BAR Meeting
July 15, 2015

ISSUE: Permit to Demolish/Capsulate, Certificate of Appropriateness and a Waiver of the Rooftop Mechanical Screening Requirement

LOCATION: 1211 Duke Street

BAR2015-00191 & BAR2015-00192

Front & Rear Elevations

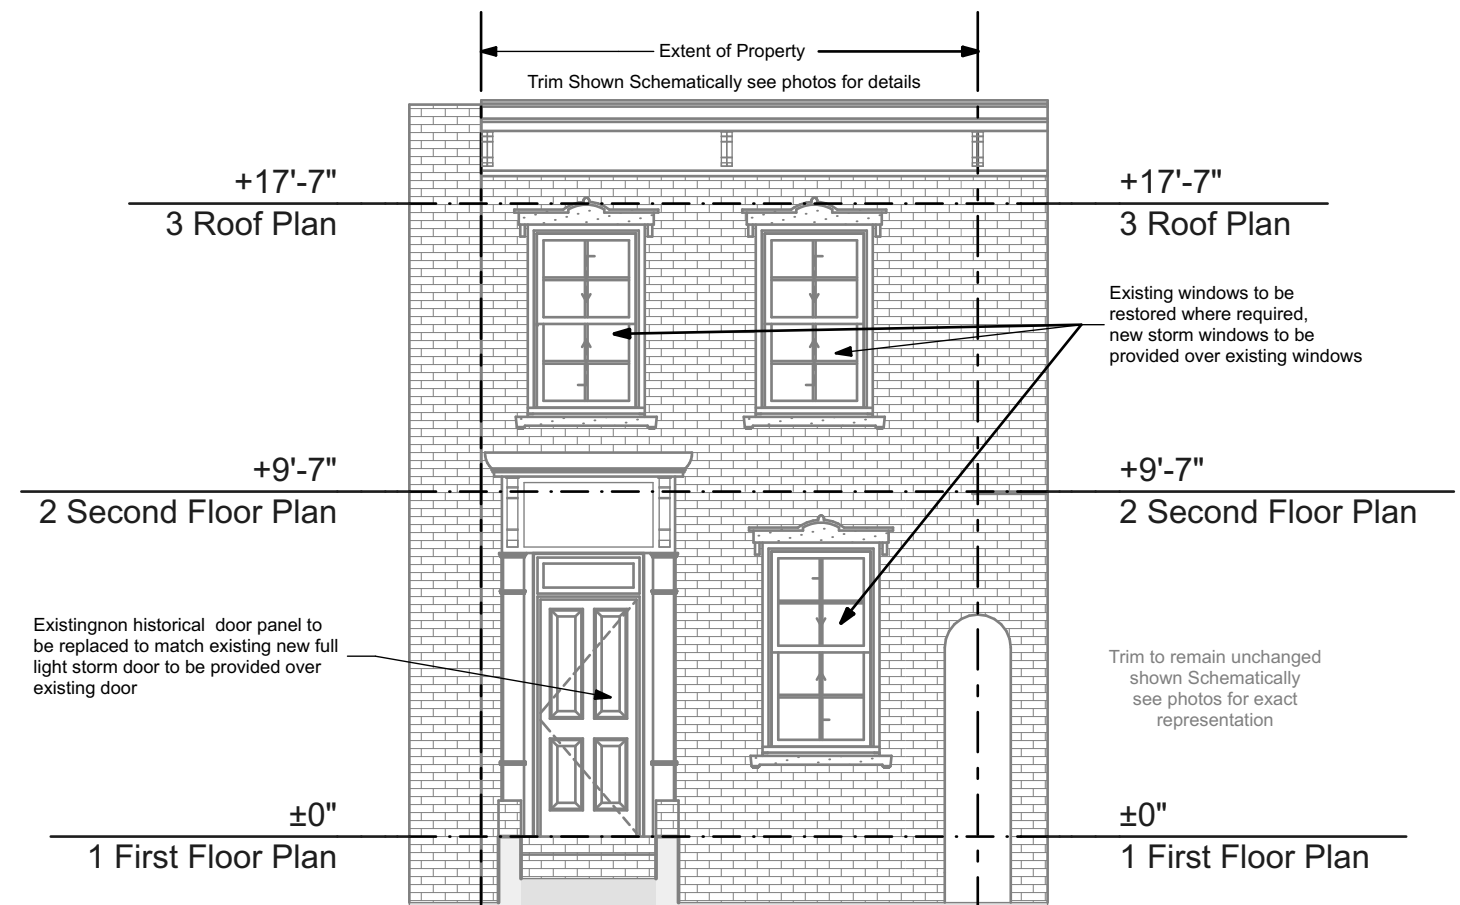
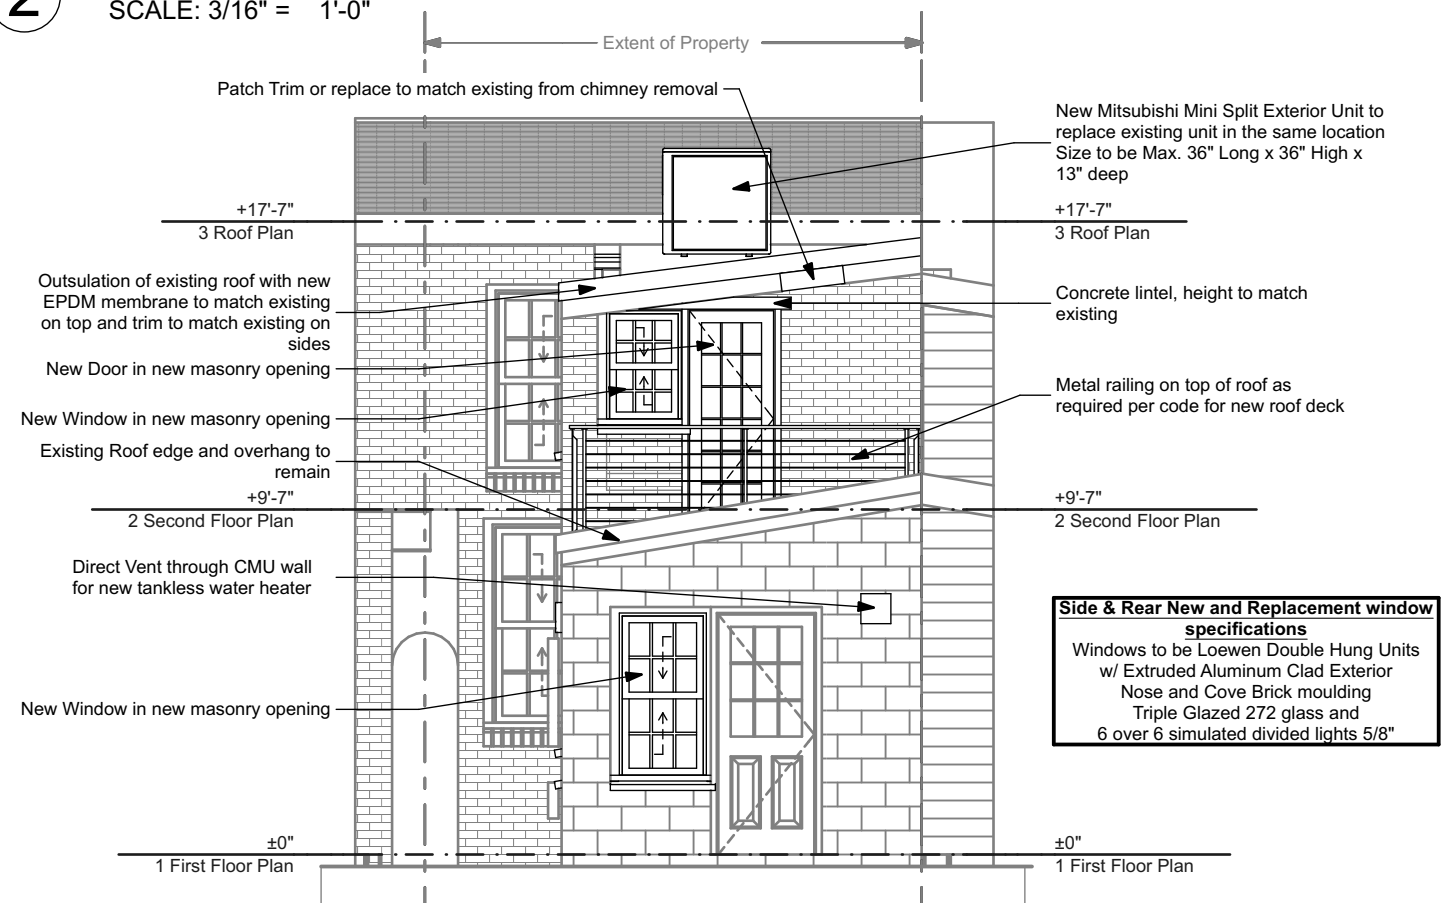
2. That the new wood front door be painted.
3. That the new storm door match the color of the new, painted front door.
4. That the statements in archaeology conditions below appear in the General Notes on all construction drawings that involve demolition or ground disturbance (including Basement/Foundation Plans, Demolition, Erosion and Sediment Control, Grading, Landscaping, Utilities, and Sheeting and Shoring) so that on-site contractors are aware of the requirements.

Left & Right Elevations

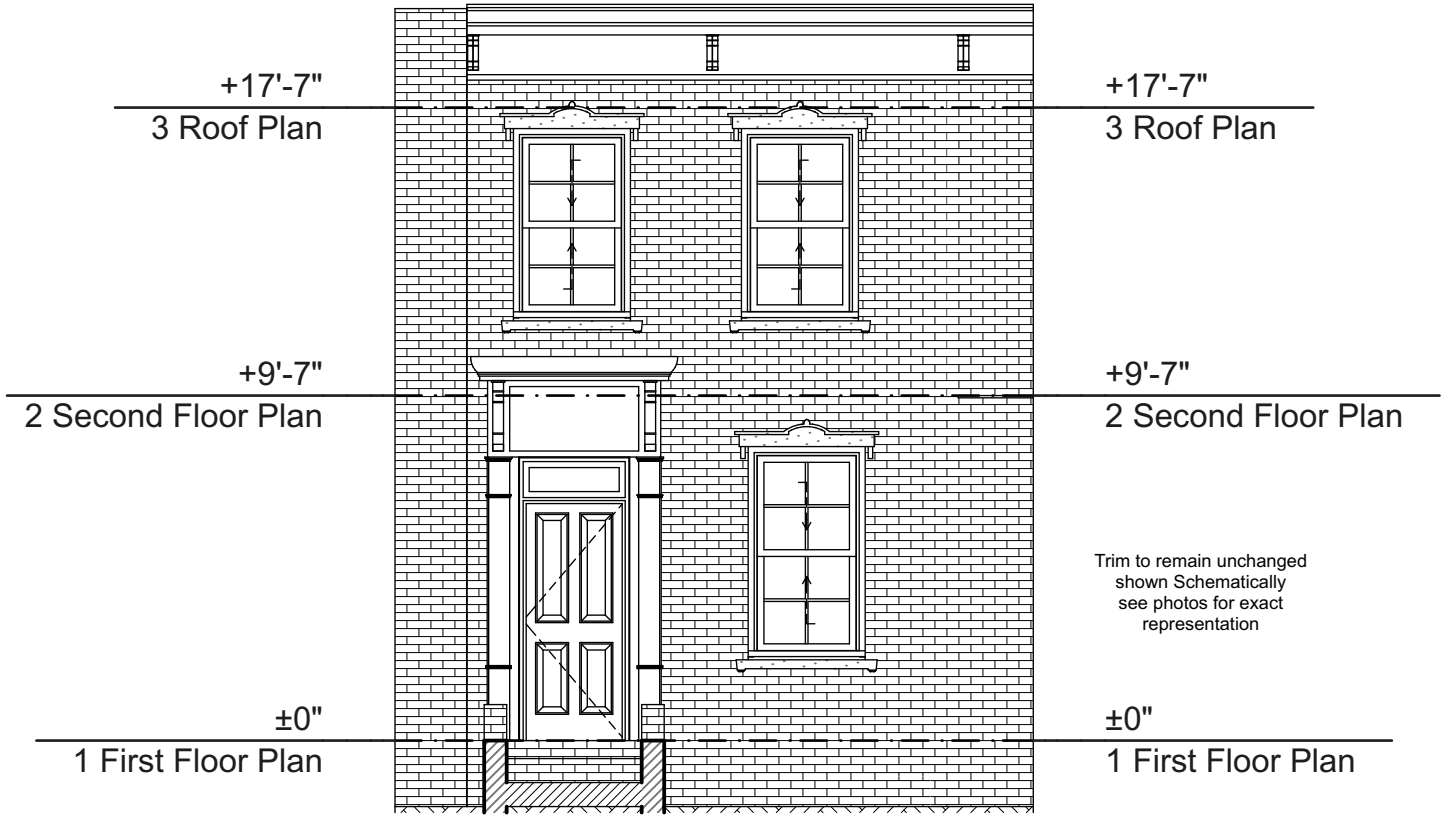
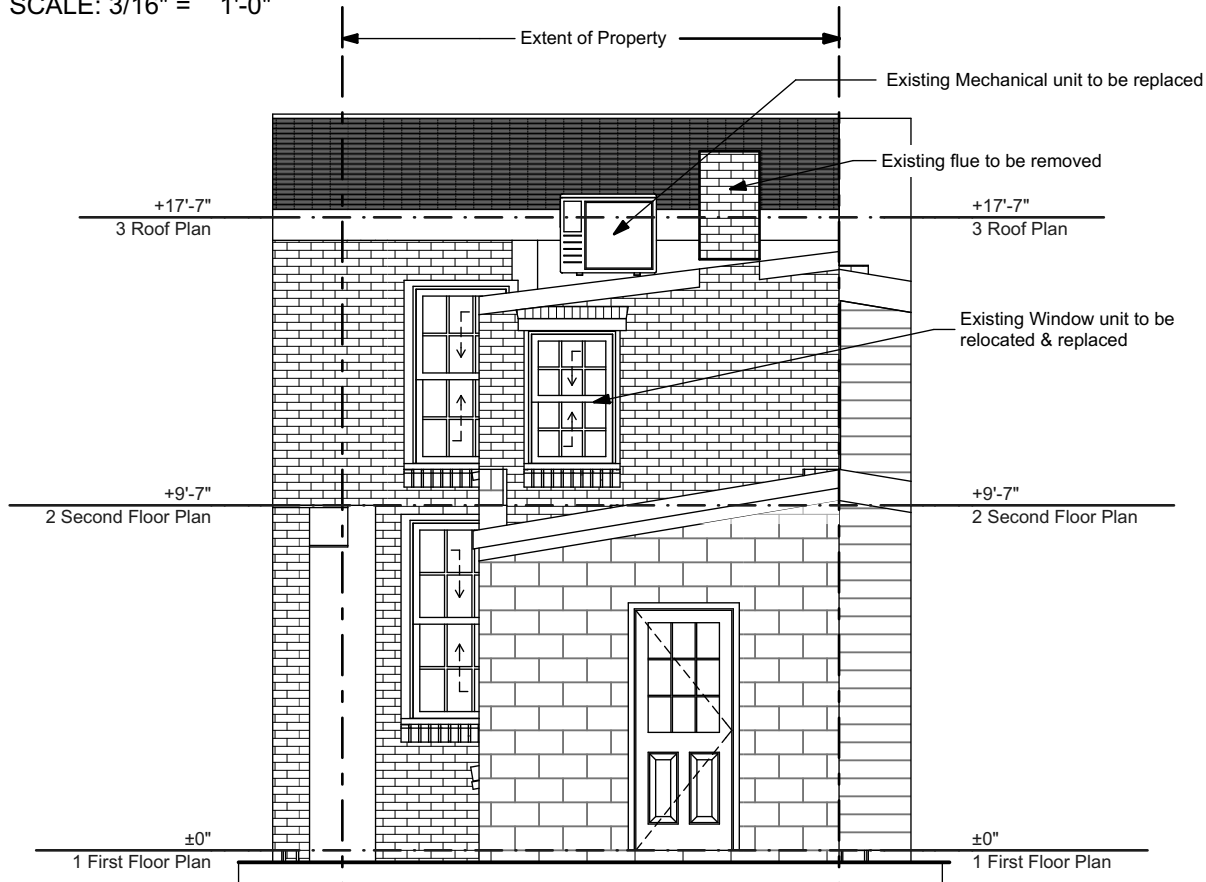
1. That the second floor window on the east elevation either be retained, replaced in the same opening or in-filled with brick and recessed slightly from the wall face. No new window openings or enlarging existing openings are recommended on this elevation.
